APPEAL SUMMARY

Appeal ID: 22215	Project Address: 4245 SE Milwaukie Ave
Hearing Date: 12/11/19	Appellant Name: Tom Jaleski
Case No.: B-021	Appellant Phone: 9712385266
Appeal Type: Building	Plans Examiner/Inspector: Preliminary
Project Type: commercial	Stories: 5 Occupancy: R-2, A-2, S-2 Construction Type: III-B
Building/Business Name: Ethos - Brookland Apartments	Fire Sprinklers: Yes - Throughout
Appeal Involves: Erection of a new structure	LUR or Permit Application No.: 19-255744-CO
Plan Submitted Option: pdf [File 1]	Proposed use: Multifamily Residential

Ethos - Brookland Apartments

SHEET NUMBER
G-100

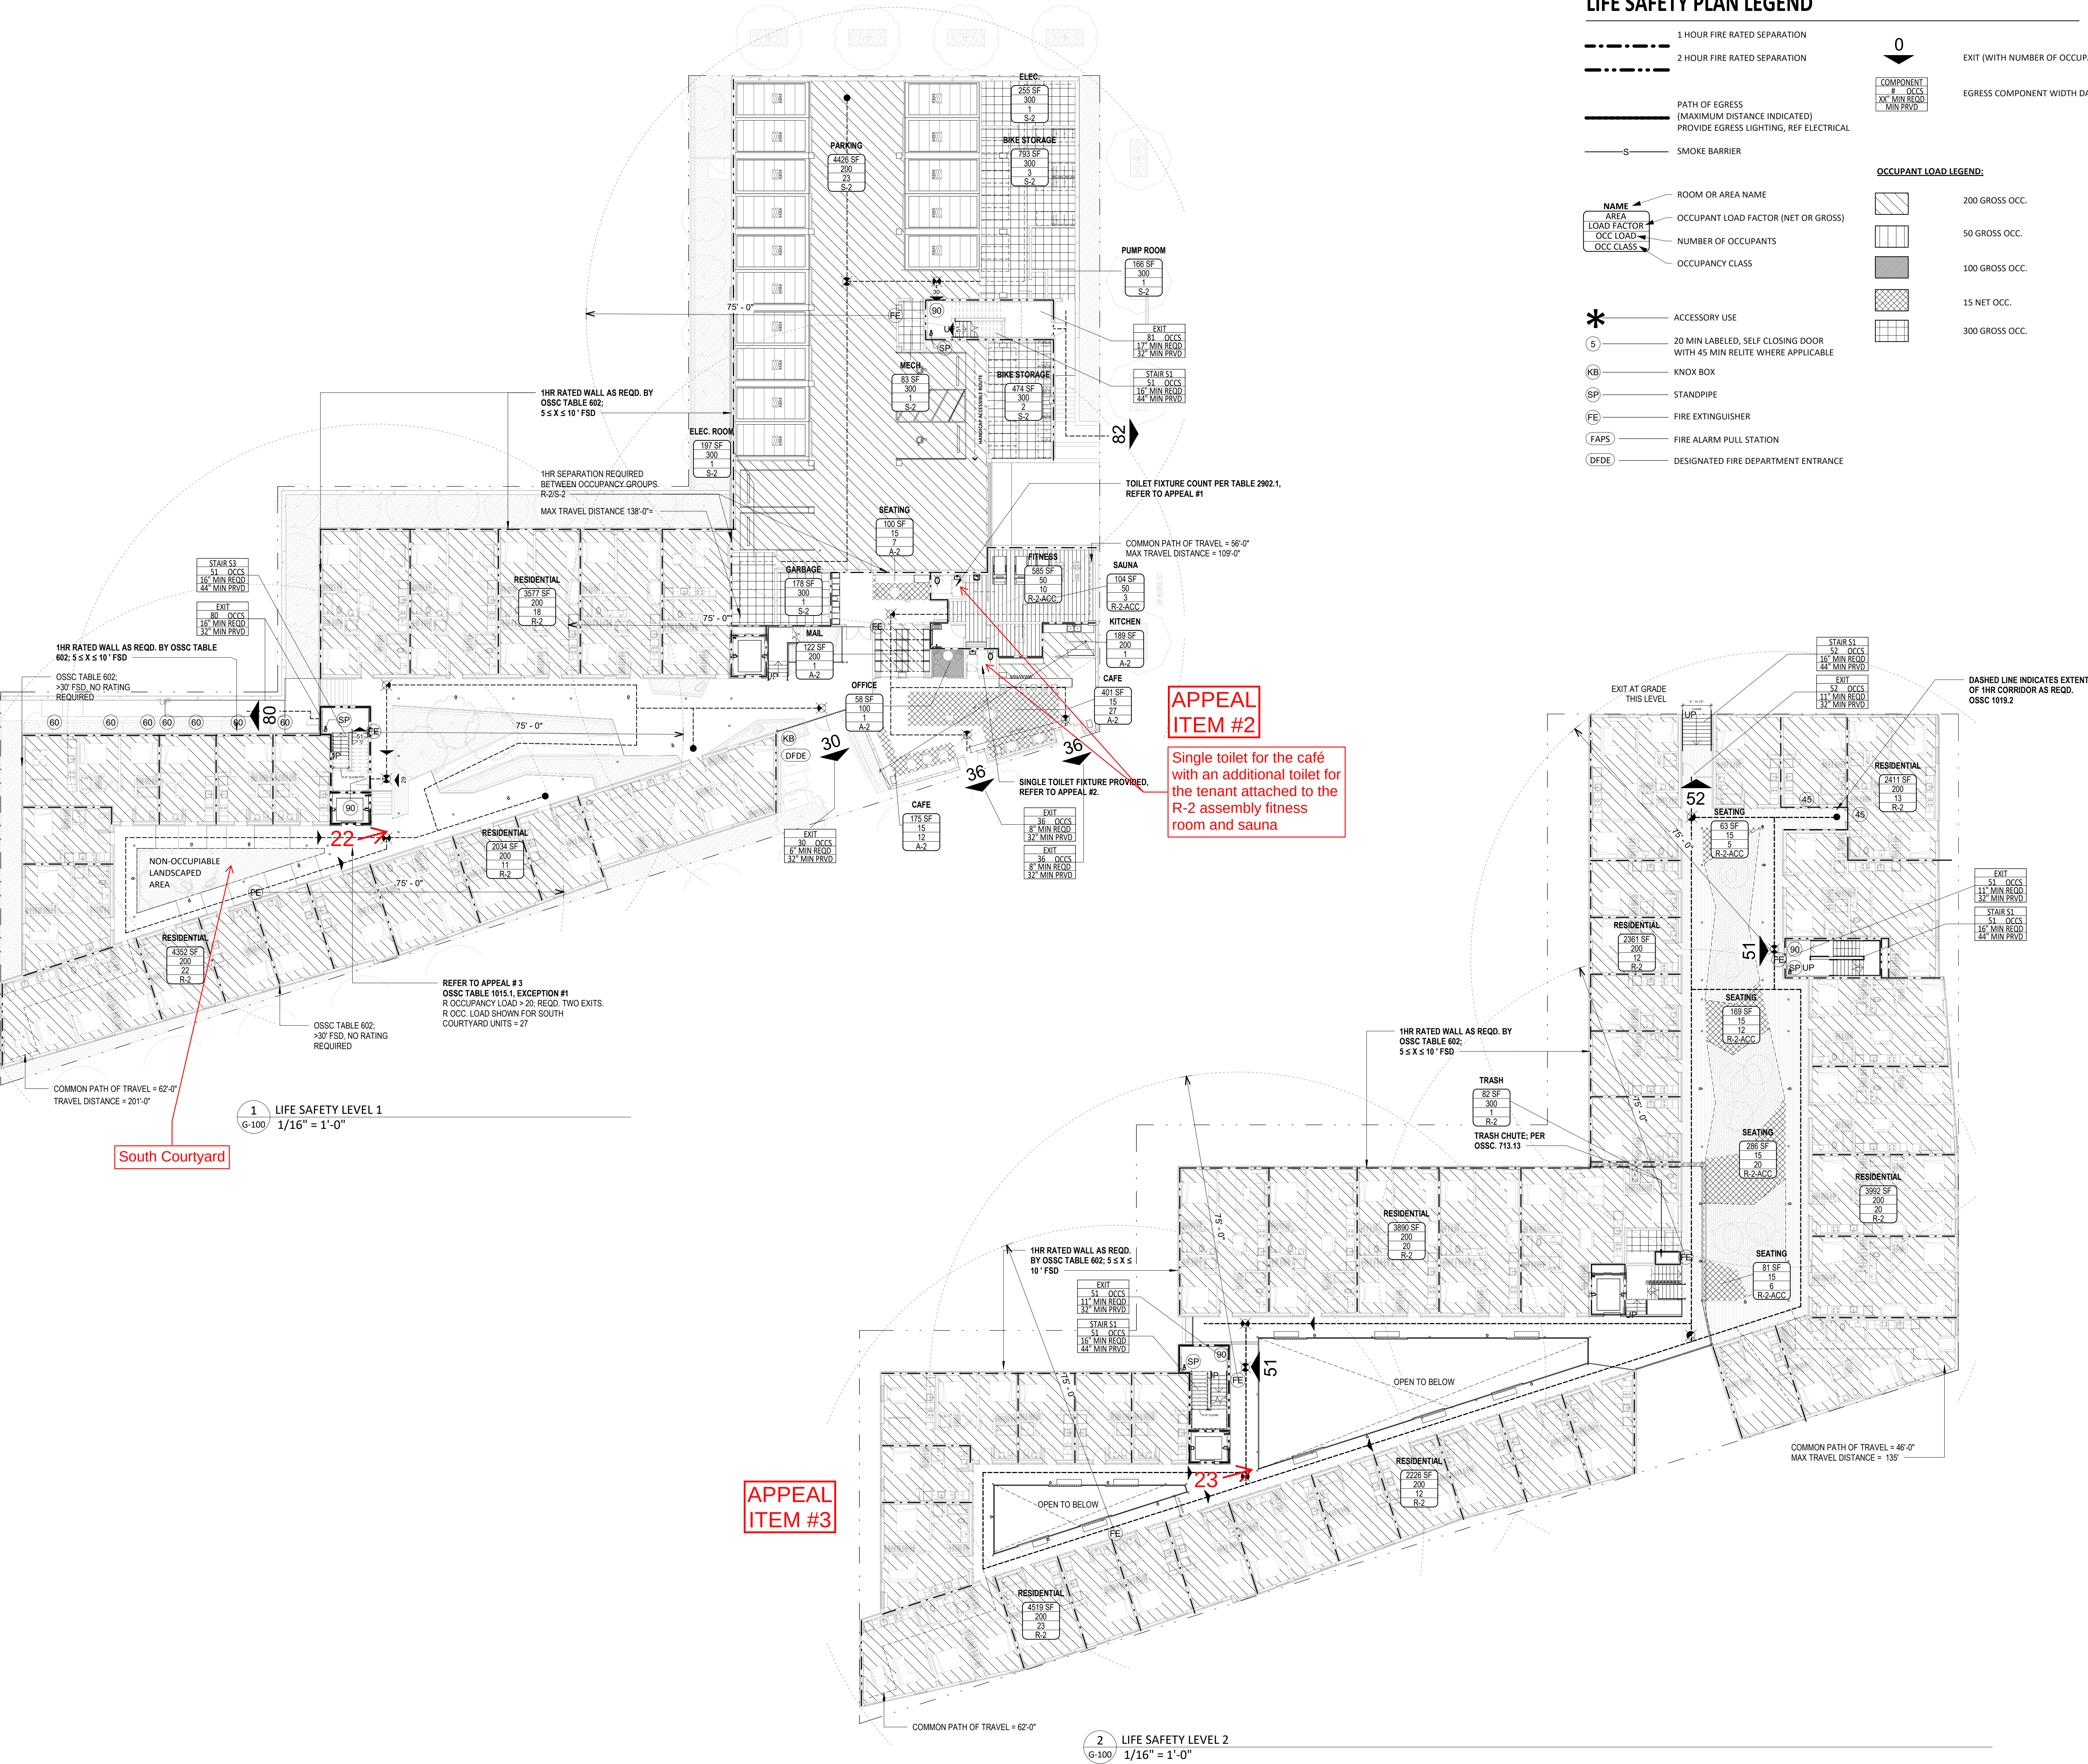
Proposed Design The proposed design is a lounge lobby for a multi-family apartment building with a café embedded in the corner. Due to the desire to not have any rated assemblies between the spaces, the design

has the entire lobby as a A-2 assembly. We propose providing one private toilet for the café with an additional toilet for the tenant attached to the R-2 assembly fitness room and sauna.

Reason for alternative Per OSSC Table 2902.1, the plumbing fixture count for an assembly occupancy classification of 60 occupants. However, the café and kitchen occupants are only 15. See attached life safety plans.

Per OSSC 2902.2 exemption 2 we would propose that the single toilet provided be adequate for the use by the café and the remaining occupants be covered by the toilet in the fitness area and to be considered as non-simultaneous with the residential units.

Proposed Design The proposed five story building includes a residential corridor that is located around a courtyard at the south end of the building. This layout is typical at Level 1 to 5. These corridors meet all the requirements of Section 1015 for a single exit including the travel distance, except that the occupant load from the corridor exceeds the 20 occupancy per Section 1015.1 exception #1 for single exit in Group R-2 occupancy. This exceed the limit at each floor by about 2-4 occupants. See the attached drawing for the location.

The proposed design is to classify these corridors open to the courtyard as egress balconies, and follow the provisions per Section 1019, including width, headroom, dead ends and projections.

**APPEAL
ITEM #3**

**APPEAL
ITEM #2**

Single toilet for the café
with an additional toilet for
the tenant attached to the
R-2 assembly fitness
room and sauna

**APPEAL
ITEM #3**

2. Single all user toilet room in lieu of separate facilities: Granted as proposed.

3. Single exit corridor with increase in maximum allowable occupant load to 22: Hold for additional information.
